Final Drainage Report – Early Grading Permit

# Waterview East Commercial El Paso County, Colorado

Project #: 196195000

PCD Filing No.: SP-22-009

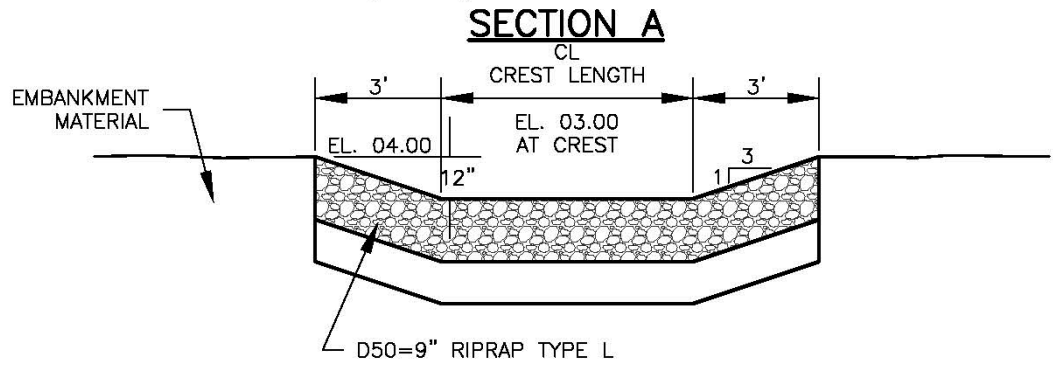
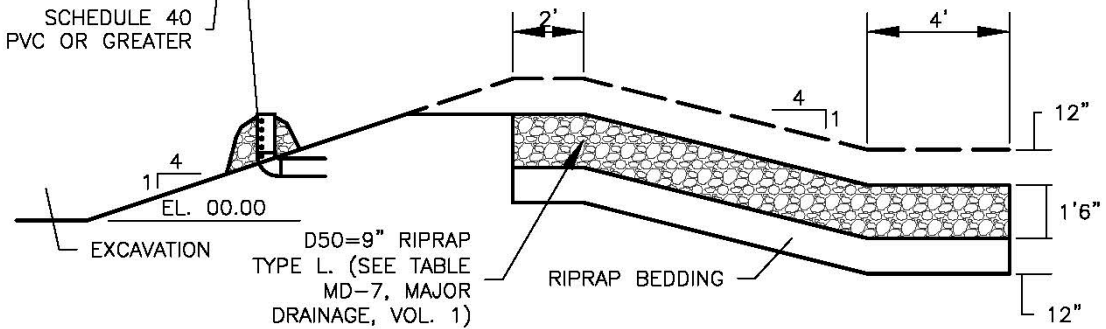
Unresolved Comment:  
- Provide sizing calculations for  
TSB ponds.

THE UDFCD FACT SHEET WITH TABLE SB-1  
IS PROVIDED IN THE APPENDIX TO SHOW  
HOW THE SEDIMENT BASINS WERE SIZED.  
TEXT WAS PROVIDED IN THE REPORT TO  
THIS EFFECT AND TRIBUTARY AREA  
CALLOUTS WERE PROVIDED IN THE TEXT  
AND THE EXHIBITS.
